RE: In the Matter of Federal-State Joint Board on Universal Service -  
CC Docket No. 96-45

**Preliminary Review  
of the  
Hatfield 3.1 Model**

**presented by US West and Sprint  
with INDETEC International  
April 7, 1997**

# POINT ANGELES WA

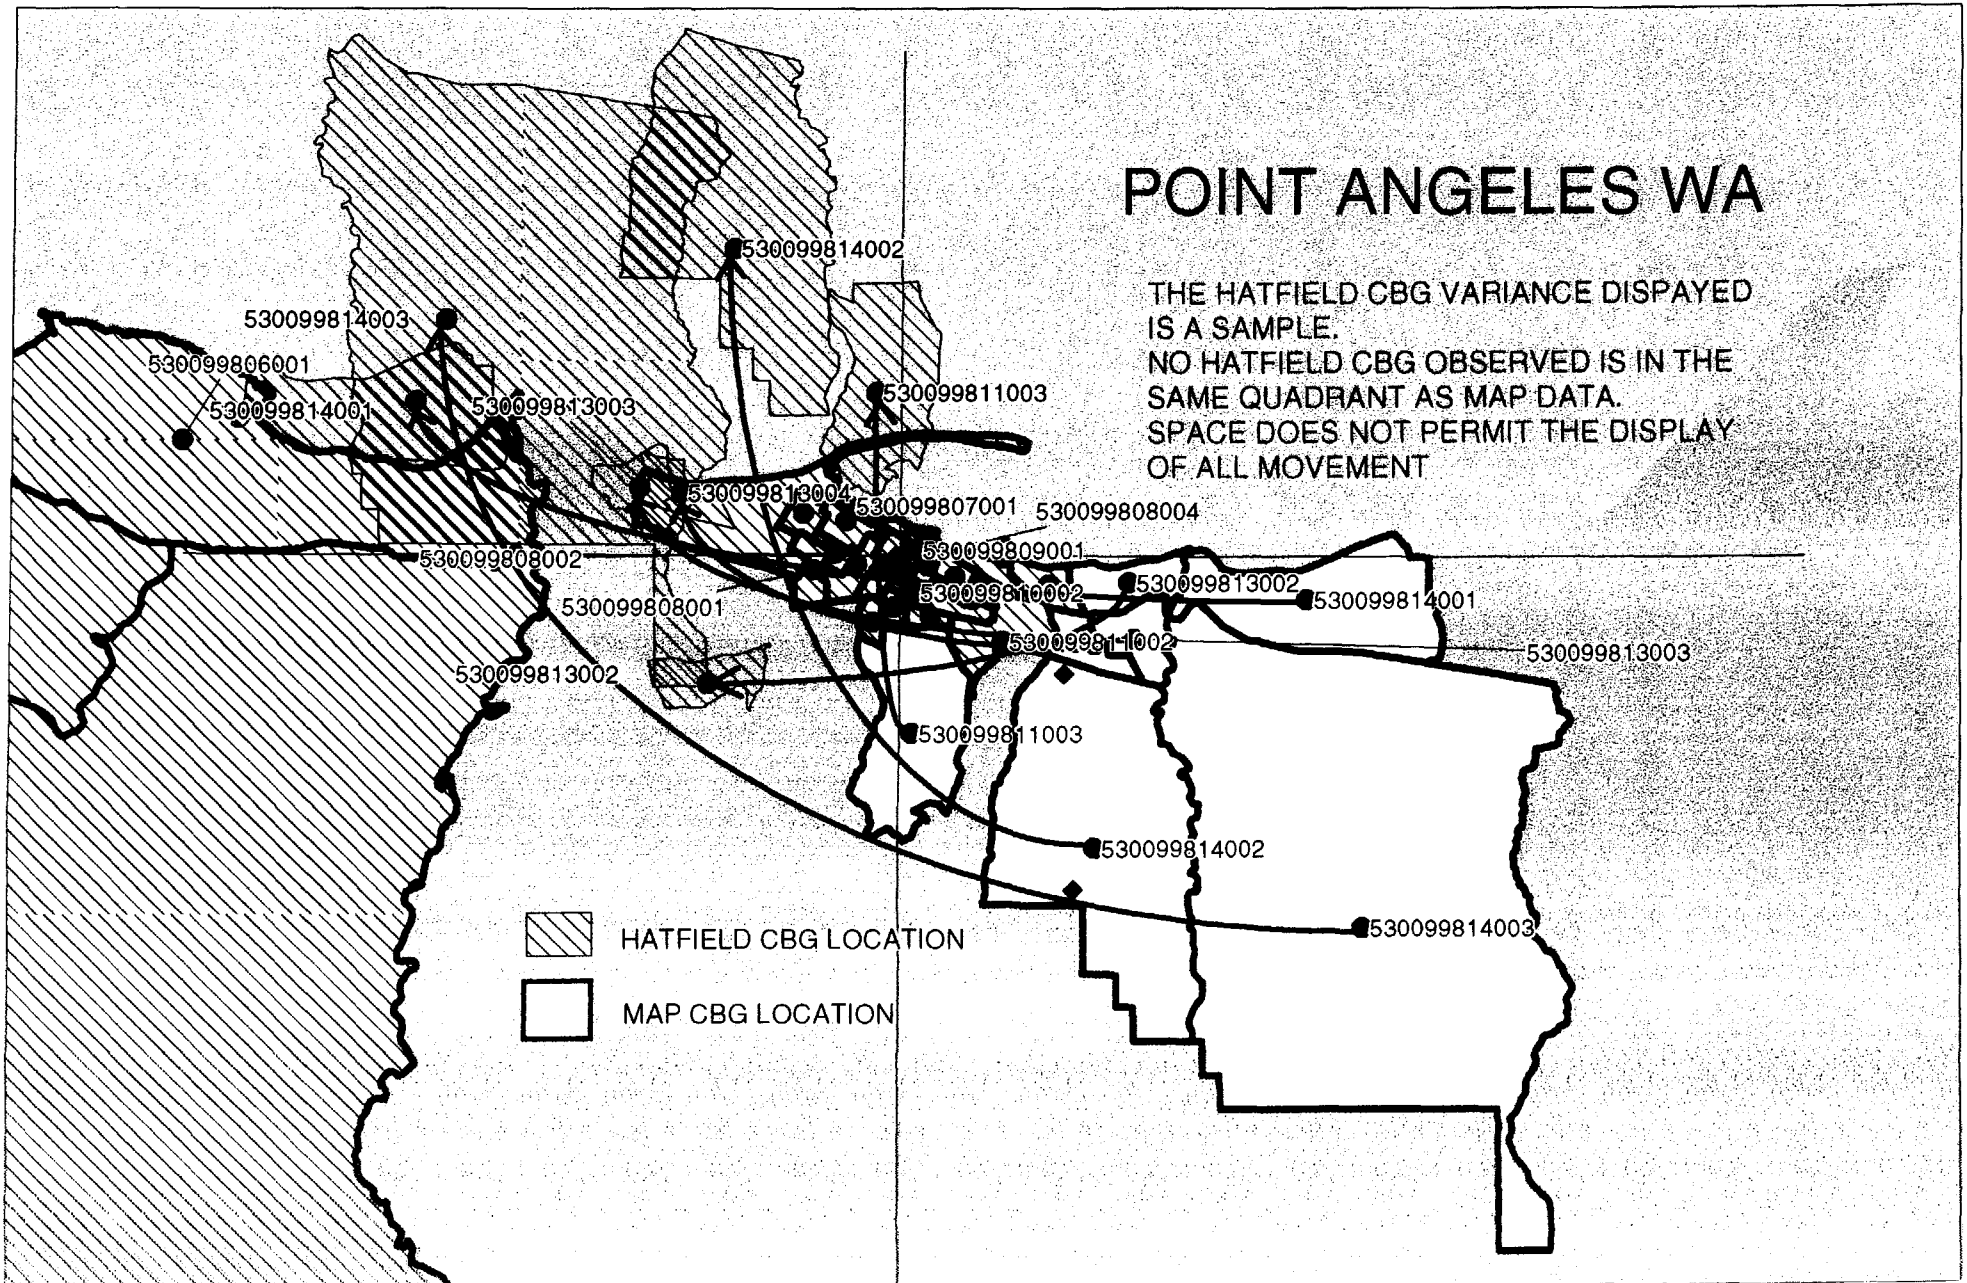
Distance from the office has also changed drastically - - but again only in some cases. The combination of orientation and distance changes has placed some centroids in the middle of water. In looking at just a few CBGs served by General Telephone in the state of Washington we have found numerous inexplicable changes. A map has been included to highlight the types of inexplicable changes that have occurred.

THE HATFIELD CBG VARIANCE DISPLAYED  
IS A SAMPLE.  
NO HATFIELD CBG OBSERVED IS IN THE  
SAME QUADRANT AS MAP DATA.  
SPACE DOES NOT PERMIT THE DISPLAY  
OF ALL MOVEMENT

To illustrate this problem, the diagram below contains 4 stylized CBGs: A, B, C and D. Each oval represents 10 households for a total of 100 households per CBG.

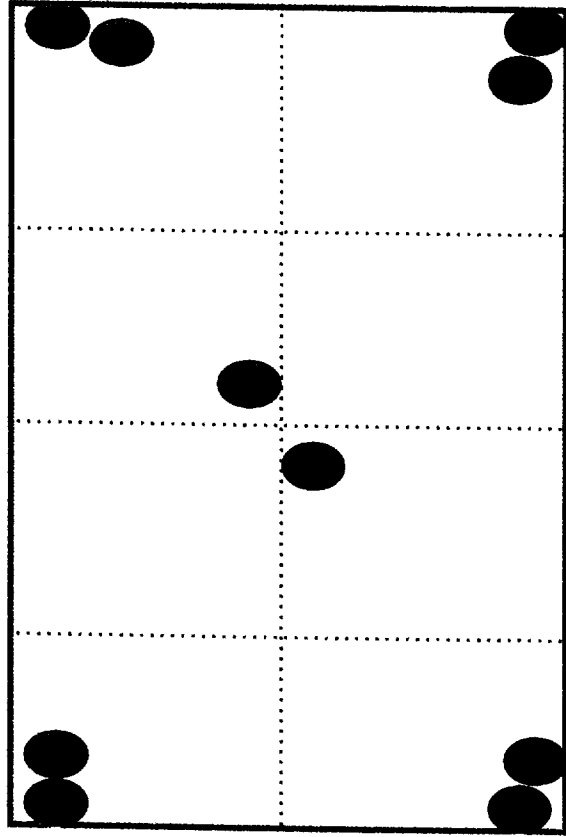
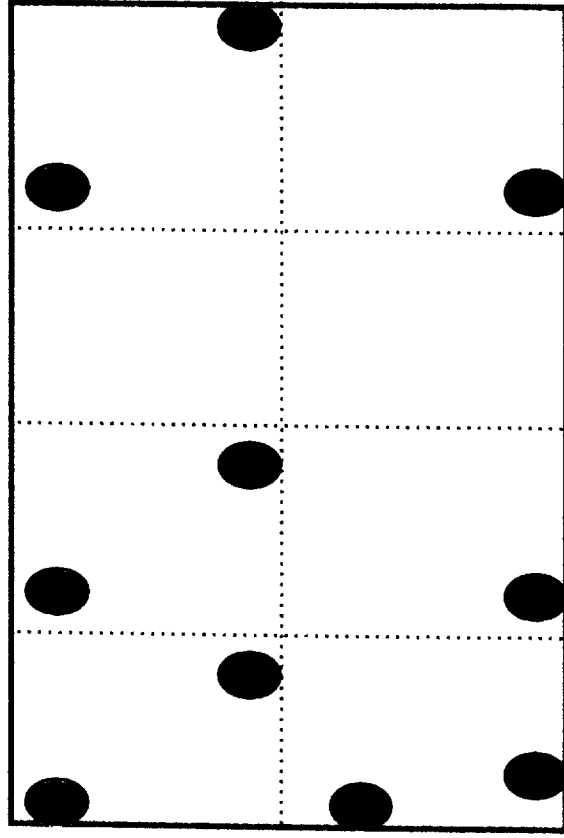
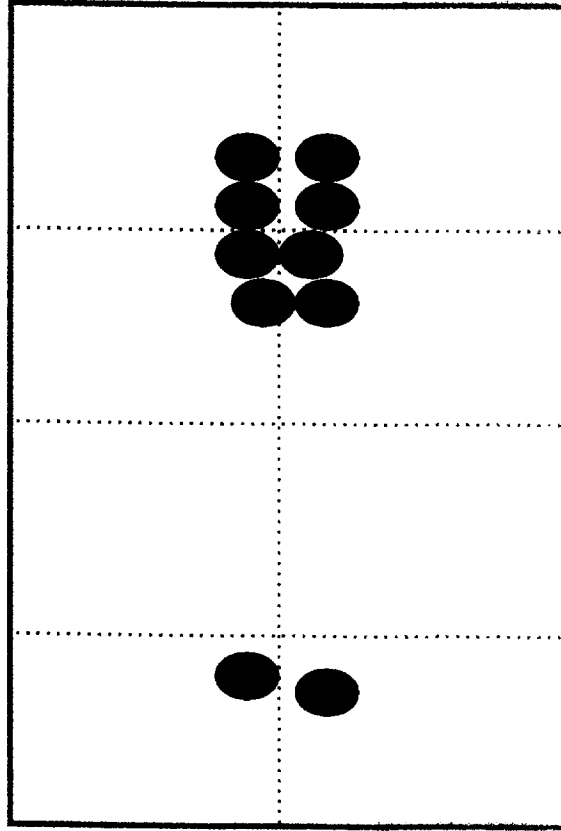
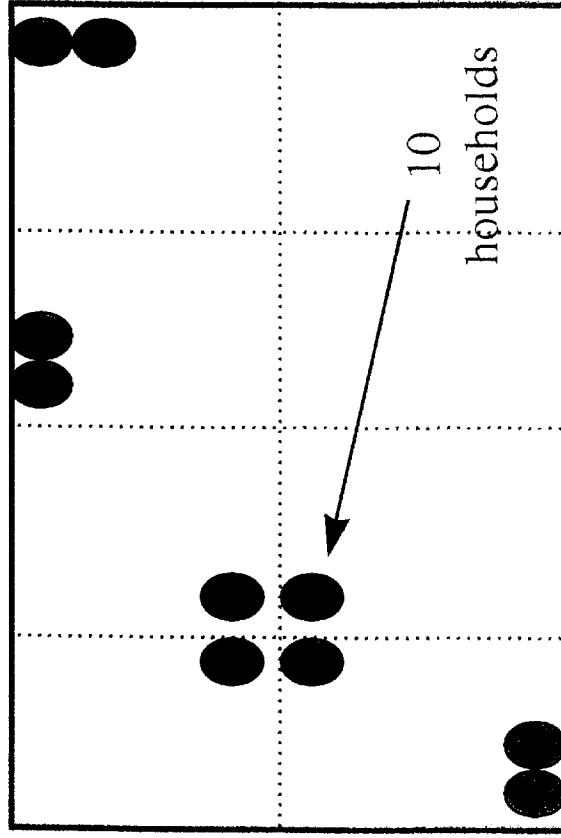
Each stylized CBG has the same land area, same number of census blocks (8, defined by the dotted line), same amount of unpopulated area (25%). However, in certain CBGs the customers are clearly situated in groupings or “clusters”. The

CBG labeled “A” shows 5 clusters. “C” shows 2 clusters. “D” shows 4 clusters and “B” does not show any obvious clusters.

- *The grouping algorithm in the Hatfield Model 3.1 would ignore the existing clusters, and build the same number of clusters, four (4), in every CBG. Eighty-five percent of customers would be placed within these 4 clusters (85% is the Hatfield default value).*

The only criteria for determining the number of clusters used in the Hatfield model is the amount of unpopulated area, which is the same in CBGs A, B, C and D.

- *More importantly, the size of the four clusters would be exactly the same for each of the four CBGs, ignoring the actual amount of area in which customers are located.*

Each household in a cluster is given a lot size of 3 acres, the lots are assumed adjacent, and this forms the area of the cluster.

- *In addition, the number of customers in each cluster would be exactly the same for each of the four CBGs.*

Each Hatfield cluster is constructed to contain  $1/4^{\text{th}}$  of 85% of customers. In doing this, existing clusters (such as those found in CBG “C”) are ignored by the model.

## HATFIELD 3.1 LOT SIZING FOR 100 SQUARE FOOT LOT

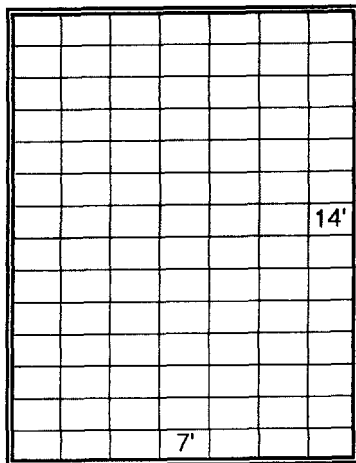
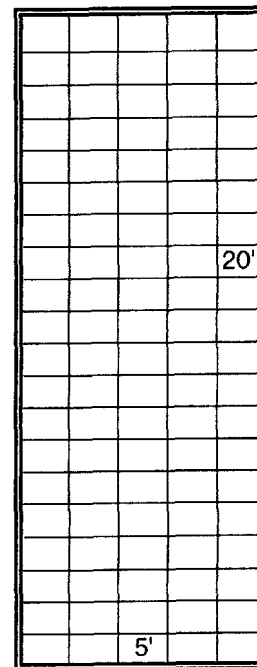
In building the lot sizes, the Hatfield model assumes that every lot is twice as deep as it is wide. Without comment on the accuracy of that assumption, let it be said that the calculation to reflect that assumption is flawed. The calculation methodology is to take the square root of the area, and multiply that by  $\frac{1}{2}$  to determine the lot frontage. They then multiply the original side by 2 to calculate the depth. Unfortunately that yields a depth to frontage ratio of 4:1, not 2:1.

Placing illustrative numbers into the description may help describe the errant situation. If the lot were 40,000 square feet, the Hatfield model would take the square root of that to determine its side as 200 feet. It would then (incorrectly) multiply that by .5 to calculate the frontage (incorrectly) at 100 feet. It would then go back to the original side of 200 feet and multiply that by 2 to come up with a side of 400 feet. That results in a side of 400 feet and a front of 100 feet - - a 4:1 ratio of depth to frontage - - with resultant construction changes as well.

What Hatfield 3.1 says it does.

$.5 * \text{Square Root of } 100$   
 $= 5 \text{ on Front}$

That means  
20' deep.

What Hatfield 3.1 actually does.

This miscalculation flows through to distribution area and investment results.

The proper multiplier for the frontage should be .7070, not  $\frac{1}{2}$ .

Correct formula should be:  $.707 * \text{Square Root of Area}$
